Ref: SSD-10398 Hanson Tweed Sand Plant Expansion

We refer to the Hanson Tweed Sand Plant Expansion (SSD-10398) development application. This letter is intended to provide comment on the Hanson SSD-10398 application in respect of potential impacts to the activities of Australian Bay Lobster Producers.

Figure 1: Hanson's proposed deceleration lane to enter the Access Lot

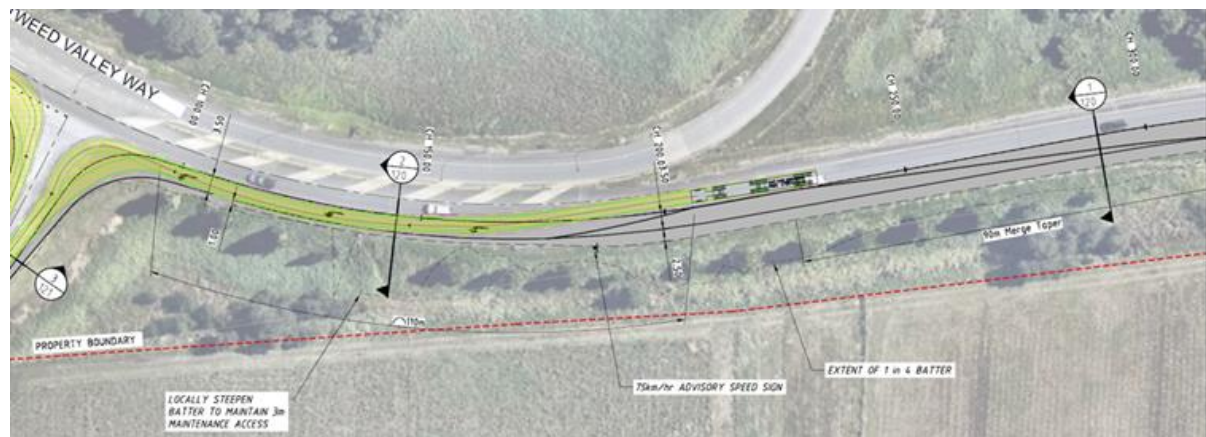
ABLP notes that this proposal addresses ABLP's concerns in respect of ABLP and Hanson traffic interaction on the Access Lot, however it fails to address concerns around the increase in overall traffic movements passing through the Tweed Valley Way interchange. The addition of the deceleration lane (Refer to Figure 1 below) also adds another traffic stream to the interchange and due to its proximity to Hanson's proposed acceleration lane (Refer to Figure 5.8 of EIS Appendix J Traffic Impact Assessment), will create a convergence point for multiple streams of high-speed traffic. In particular, the addition of the deceleration lane in conjunction with the acceleration lane will result in the following traffic streams interacting between the M1 Pacific Motorway southbound exit and the overpass bridge of the Tweed Valley Way interchange:

- Traffic exiting the M1 Pacific Motorway southbound and decelerating from 110km/hr to 80km/hr.
- Heavy vehicles accelerating to 80km/hr from the Hanson acceleration lane travelling through the Tweed Valley Way interchange (one every three minutes).
- Hanson heavy vehicles (one every three minutes) along with ABLP operations and construction vehicles decelerating via the deceleration lane to enter the Access Lot.
- ABLP vehicles exiting the Access Lot onto the Tweed Valley Way interchange and accelerating to 80km/hr to travel through the Tweed Valley Way interchange.
- ABLP vehicles exiting the Access Lot by right hand turn onto the Tweed Valley Way interchange intending to travel south on the M1 Pacific Motorway.
- ABLP traffic entering the Access Lot via right hand turn from the M1 Pacific Motorway southbound entrance lane of the interchange.

The proximity of the termination/merge point of Hanson's proposed acceleration lane with the start of Hanson's proposed deceleration lane, and the interaction of heavy vehicles accelerating into the

path of heavy vehicles decelerating at this juncture, gives rise to a heightened safety concern for road users in the vicinity.

ABLP proposes that Hanson relocate the TSPE access point to the M1 Pacific Motorway (southbound), south of the Tweed Valley Way interchange. In order to achieve this, it will be necessary to create a deceleration lane commencing at the M1 Pacific Motorway and extending along the western boundary of ABLP's lot 1 DP1192506 to Hanson's lot 1 DP1250570. To achieve this ABLP offers to grant an easement to Hanson over lots 708 and 709 DP1000580 for the purpose of creating the deceleration lane from the motorway through to Hanson's lot 1 DP1250570. If this access point were adopted it would reduce the additional heavy vehicle traffic at the Tweed Valley Way interchange by 31,000 movements (50%) whilst concurrently circumventing any interaction between ABLP and Hanson traffic on the Access Lot. Further, it would remove the proximity issue with the current acceleration and deceleration lanes proposed by Hanson and reduce the safety risk associated with having multiple streams of varying traffic types converge in close proximity. It is also expected to alleviate the long-term congestion pressures which are otherwise anticipated.
